SACOMBE HOUSE

EXISTING AND PROPOSED WEST ELEVATION

DR-200-WEST | B |

Proposed West Elevation

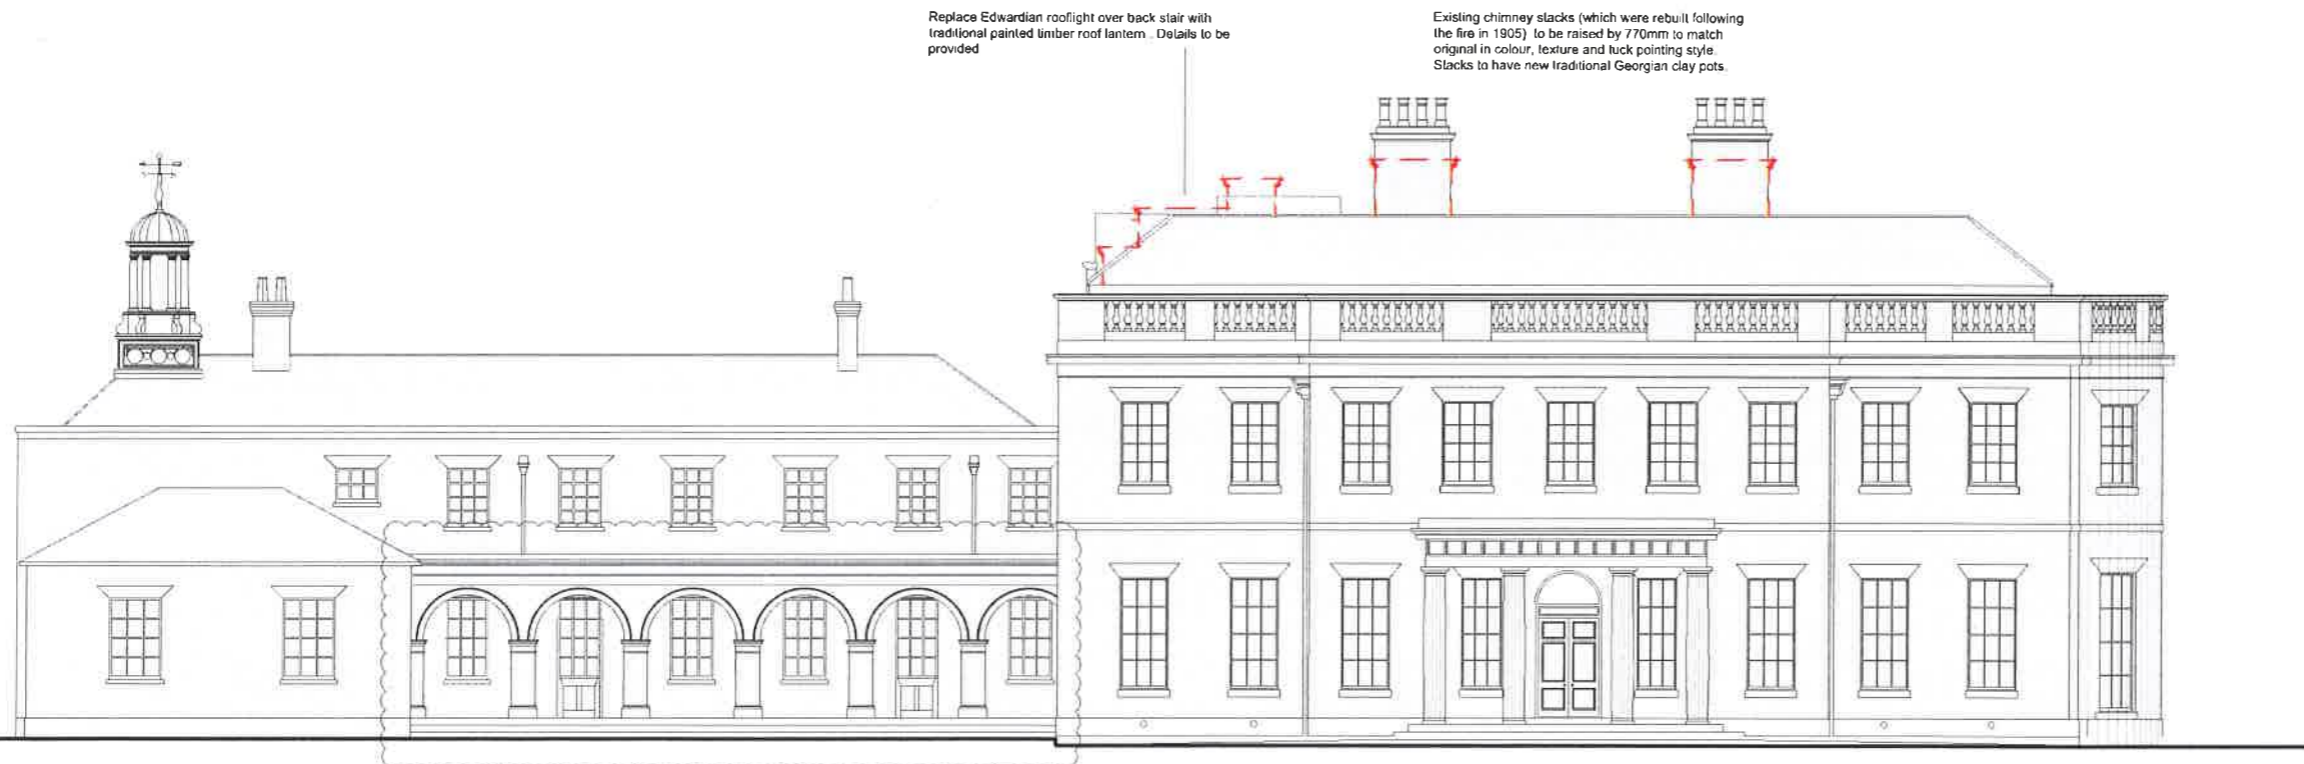
Replace Edwardian rooflight over back stair with traditional painted timber roof lantern. Details to be provided

Existing chimney stacks (which were rebuilt following the fire in 1905) to be raised by 770mm to match original in colour, texture and tuck pointing style. Stacks to have new traditional Georgian clay pots.

The design for the arcade is to revert to the consented scheme under the Application Ref:3/12/0366/LB
